Proposal for draft amendment to Regulation No 107
(M₂ and M₃ vehicles)

Note: This document supersedes document ECE/TRANS/WP.29/GRSG/2008/22.

Model A

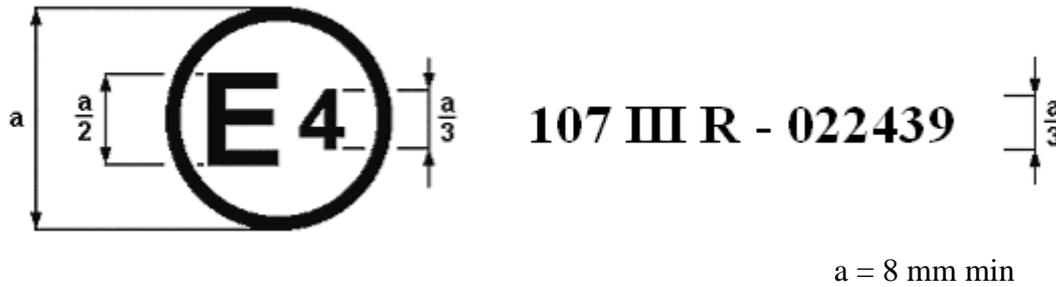
NOTE: Approval no in the above model to be modified by the Secretariat to read 032439

The above approval mark affixed to a vehicle shows that the vehicle type concerned has, with regard to its constructional features, been approved in the Netherlands (E 4) for Class III, pursuant to Regulation No. 107 under approval number **032439**. The approval number indicates that the approval was granted according to the requirements of Regulation No. 107 as amended by the **03** series of amendments.

Model B

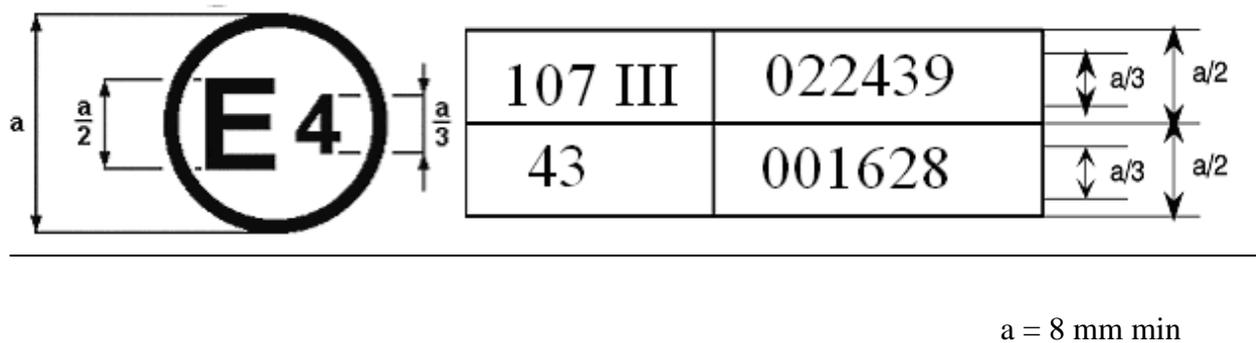
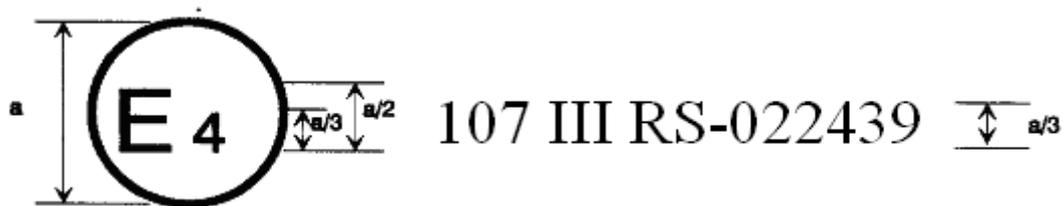
NOTE: R.107 approval no in the above model to be modified by the Secretariat to read 032439

The above approval mark affixed to a vehicle shows that the vehicle type concerned has been approved in the Netherlands (E 4) pursuant to Regulations Nos. 107 and 43.* / The first two digits

of the approval numbers indicate that, on the dates on which these approvals were granted Regulation No. 107 included the **03** series of amendments and Regulation No. 43 was in its original form.
